PIC24FJ256GB110 Family Silicon Errata and Data Sheet Clarification

The PIC24FJ256GB110 family devices that you have received conform functionally to the current Device Data Sheet (DS39897C), except for the anomalies described in this document.

Data Sheet Clarifications

FIGURE 2-3 FREQUENCY vs. ESR PERFORMANCE FOR SUGGESTED VCAP

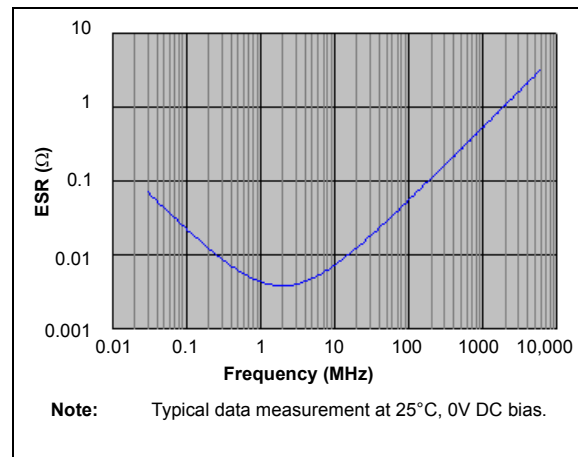
Section 2.4 Voltage Regulator Pins (ENVREG/DISVREG and VCAP/VDDCORE) has been replaced with a new and more detailed section. The entire text follows:

When the regulator is enabled, a low-ESR ($< 5\Omega$) capacitor is required on the VCAP/VDDCORE pin to stabilize the voltage regulator output voltage. The VCAP/VDDCORE pin must not be connected to VDD and must use a capacitor of $10\mu\text{F}$ connected to ground. The type can be ceramic or tantalum. Suitable examples of capacitors are shown in [Table 2-1](#). Capacitors with equivalent specifications can be used.

Designers may use [Figure 2-3](#) to evaluate ESR equivalence of candidate devices.

FIGURE 2-4 DC BIAS VOLTAGE vs. CAPACITANCE CHARACTERISTICS

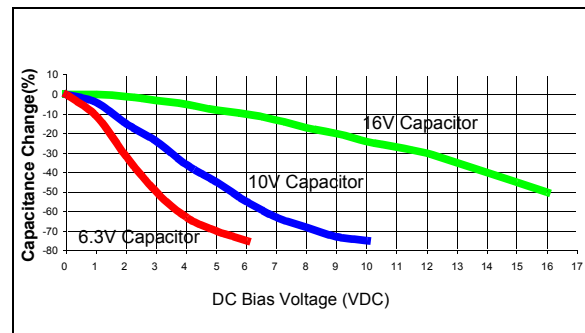
In addition to temperature tolerance, the effective capacitance of large value ceramic capacitors can vary substantially, based on the amount of DC voltage applied to the capacitor. This effect can be very significant, but is often overlooked or is not always documented.

A typical DC bias voltage vs. capacitance graph for 16V, 10V and 6.3V rated capacitors is shown in Figure 2-4.

When selecting a ceramic capacitor to be used with the internal voltage regulator, it is suggested to select a high-voltage rating, so that the operating voltage is a small percentage of the maximum rated capacitor voltage. For example, choose a ceramic capacitor rated at 16V for the 2.5V core voltage. Suggested capacitors are shown in Table 2-1.

FIGURE 29-1: PIC24FJ256GB110 FAMILY VOLTAGE-FREQUENCY GRAPH (INDUSTRIAL)

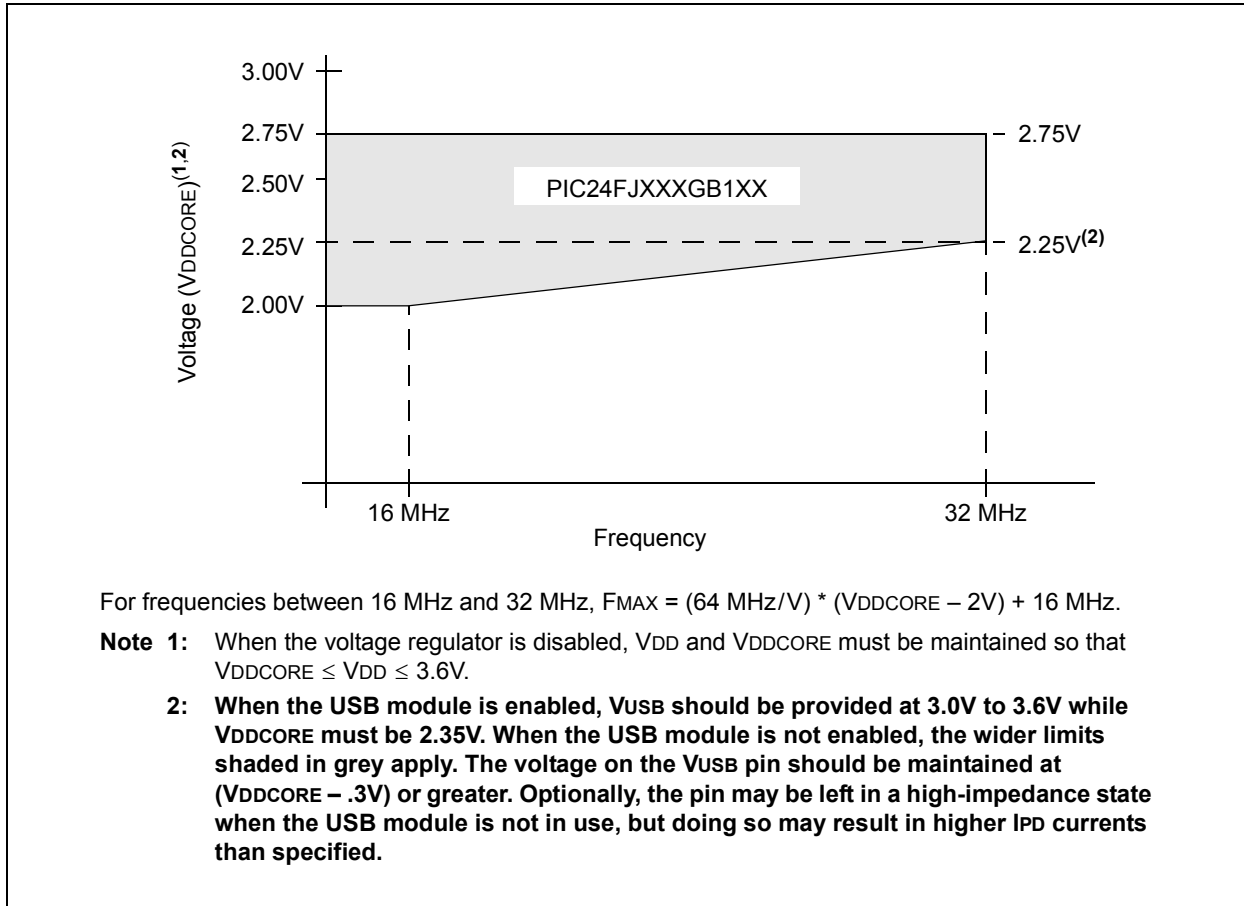
Figure 29-1 (“PIC24FJ256GB110 Family Voltage-Frequency Graph”) is amended by adding an additional footnote. The updated figure is shown below (changes in **bold**; bold in original removed for clarity).
